**Intel 450KX/GX PCIset  
Specification Update  
82454KX/GX (PB)  
82453KX/GX (MC)  
82452KX/GX (DP)  
82451KX/GX (MIC)**

Release Date: August 1998

Order Number: 243109-015

### 3. CMOS Overshoot/Undershoot Specification

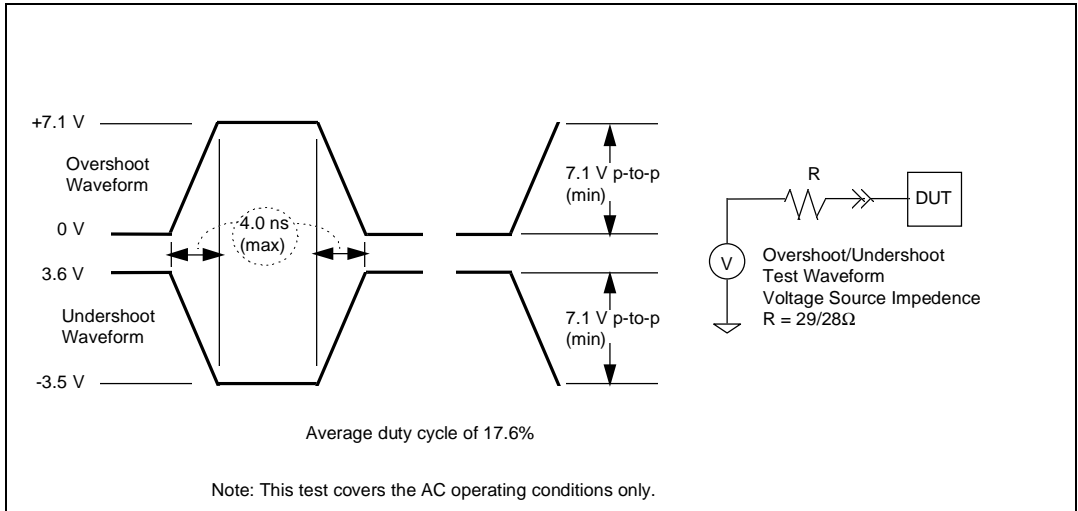
The following will be added to Chapter 4, Section 2.4, “Intel 450KX/GX Undershoot Specification,” in the *Intel 450KX/GX PCiset* datasheet, and the section will be retitled “Intel 450KX/GX Overshoot/Undershoot Specifications.”

The 3.3 V tolerant CMOS signals of the processor bus allow for the following maximum AC waveforms:

#### 6. ***Inbound Write Posting May Cause Write Failure***

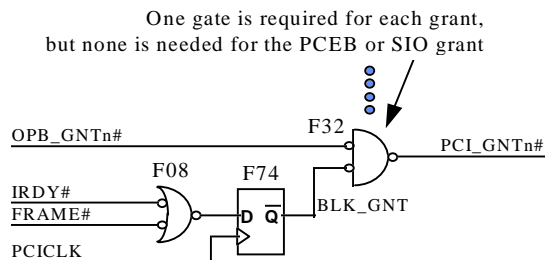
**PROBLEM:** During an inbound posted write burst, the 82454 PB may use the same data buffer for two adjacent transactions. This causes the first write to use and deallocate the data from the second write, corrupting data

and incorrectly deallocating a data buffer. When the data phase for the second write arrives, DBSY# may be asserted for some time, with no data phase or DRDY# assertion. When the PCI master completes the write burst, the deallocated buffer is never rewritten, resulting in a system hang with DBSY# asserted.

**IMPLICATION:** Enabling inbound write posting may cause data corruption followed by a system hang. Disabling inbound write posting may result in significant I/O performance loss.

**WORKAROUND:** An external arbiter should be implemented which allows inbound posting to be enabled, and guarantees at least two idle cycles between inbound PCI requests.

This arbiter must not perform overlapped arbitration. One way to ensure this is to implement the circuit described below, external to the arbiter. The actual workaround involves waiting for a bus idle before allowing a new grant to be issued. The IOQ depth must still be set to 1, and 2:1 interleaving must be used, to work around other errata which may surface when inbound write posting is enabled (even with this workaround). Note that this latter restriction requires at least 4 SIMM DRAM modules to be loaded at all times.

This following circuit is an implementation of the described workaround:

This workaround will allow inbound write posting to be enabled on A2 450KX PCIsset silicon, and will not affect the functionality of B0 450KX/GX PCIsset silicon, though a slight performance loss may result if this workaround is used with the B0 stepping. Enabling inbound posting by using this workaround is a significant performance enhancement for systems with A2 450KX PCIsset silicon; refer to Intel's World Wide Web site for more details on the performance loss incurred by disabling inbound write posting (at URL <http://www.intel.com/procs/support/ppro/82450.htm>).

**Figure 1. V<sub>CC</sub> Increase vs. T<sub>CASE</sub> Drop for DPLL Failure (Worst Case)**

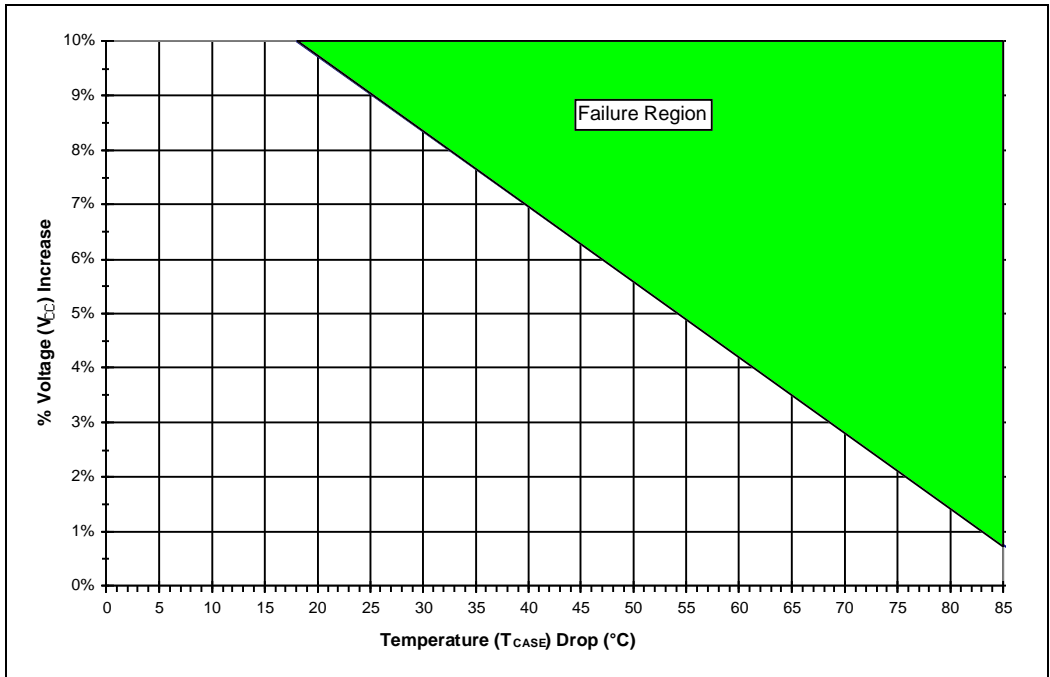
The current specification states that the Intel 450KX/ PCIsset is operational over a T<sub>CASE</sub> range of 0 - 85 °C and a V<sub>CC</sub> range of 3.3 V ± 5%.

After a device has undergone a hard reset of the DPLL (via the PLLRST pin), a drop in T<sub>CASE</sub> accompanied by an increase in V<sub>CC</sub> may cause this erratum to occur. The magnitude of the temperature drop and supply voltage increase required to cause this failure is graphed below:

**IMPLICATION:** If the  $T_{CASE}$  of any Intel 450KX PCIsset component is allowed to decrease by more than 18°C after the point at which DPLL lock is obtained after a DPLL hard reset, a positive voltage swing may cause the component to lose its internal clock for 2 - 500 processor bus clocks. This may result in a system hang, lost data, or other unpredictable system failure (note that if the component is not processing commands or data for the time during which the internal clock is lost, no failure will be observed). The larger the temperature drop and/or voltage swing, the more likely the failure.

### 3. CMOS Overshoot/Undershoot Specification

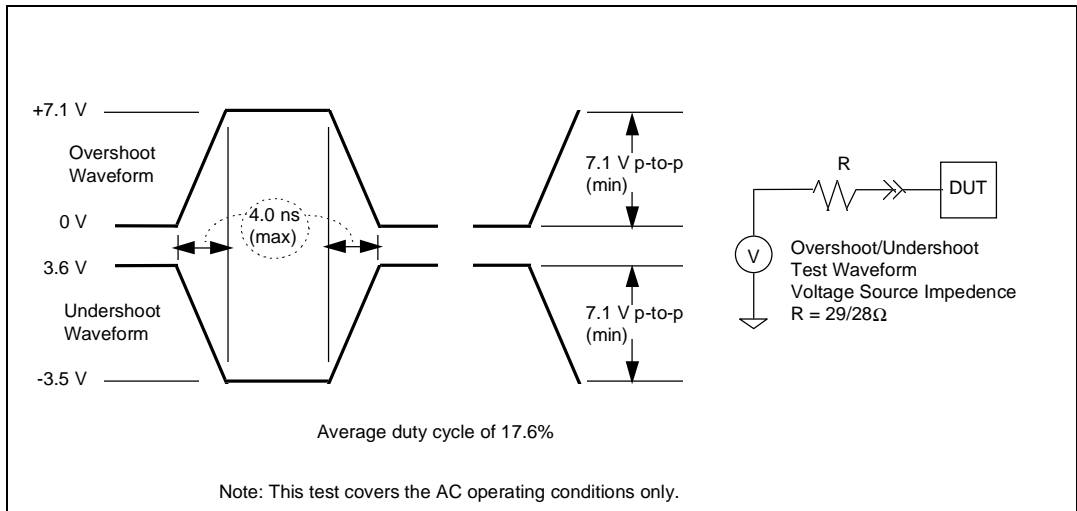
The following will be added to Chapter 4, Section 2.4, “Intel 450KX/GX Undershoot Specification,” in the *Intel 450KX/GX PCISSET* datasheet, and the section will be retitled “Intel 450KX/GX Overshoot/Undershoot Specifications.”

The 3.3 V tolerant CMOS signals of the processor bus allow for the following maximum AC waveforms:

**Figure 1. V<sub>CC</sub> Increase vs. T<sub>CASE</sub> Drop for DPLL Failure (Worst Case)**

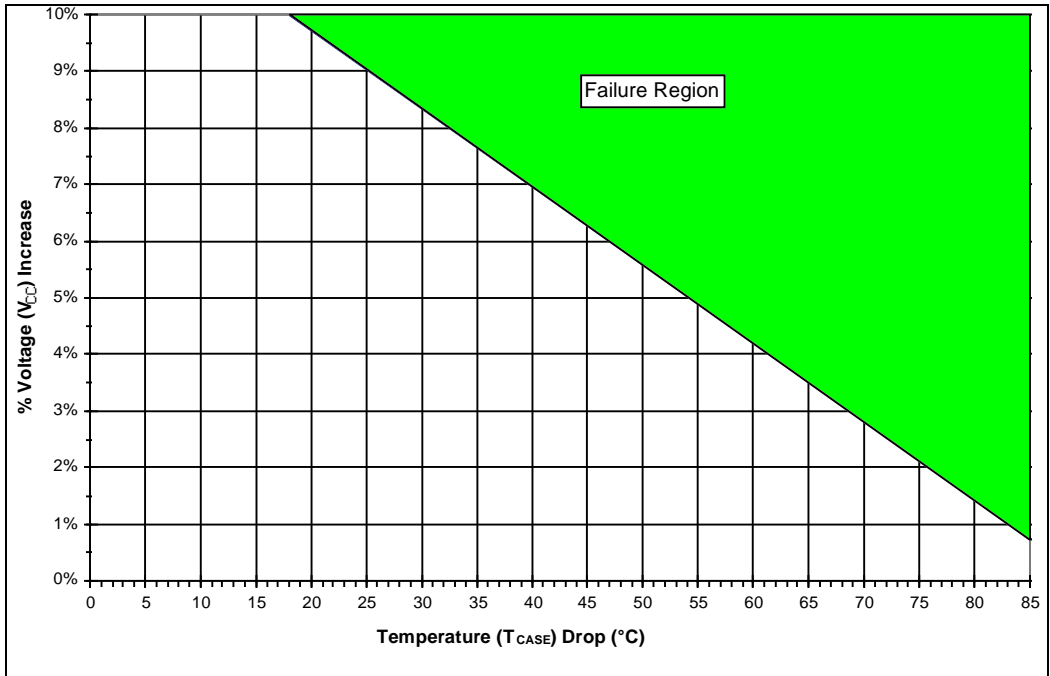
The current specification states that the Intel 450GX PCIsset is operational over a T<sub>CASE</sub> range of 0 - 85 °C and a V<sub>CC</sub> range of 3.3 V ± 5%.

After a device has undergone a hard reset of the DPLL (via the PLLRST pin), a drop in T<sub>CASE</sub> accompanied by an increase in V<sub>CC</sub> may cause this erratum to occur. The magnitude of the temperature drop and supply voltage increase required to cause this failure is graphed below:

**IMPLICATION:** If the T<sub>CASE</sub> of any Intel 450GX PCISSET component is allowed to decrease by more than 18 °C after the point at which DPLL lock is obtained after a DPLL hard reset, a positive voltage swing may cause the component to lose its internal clock for 2 - 500 processor bus clocks. This may result in a system hang, lost data, or other unpredictable system failure (note that if the component is not processing commands or data for the time during which the internal clock is lost, no failure will be observed). The larger the temperature drop and/or voltage swing, the more likely the failure.
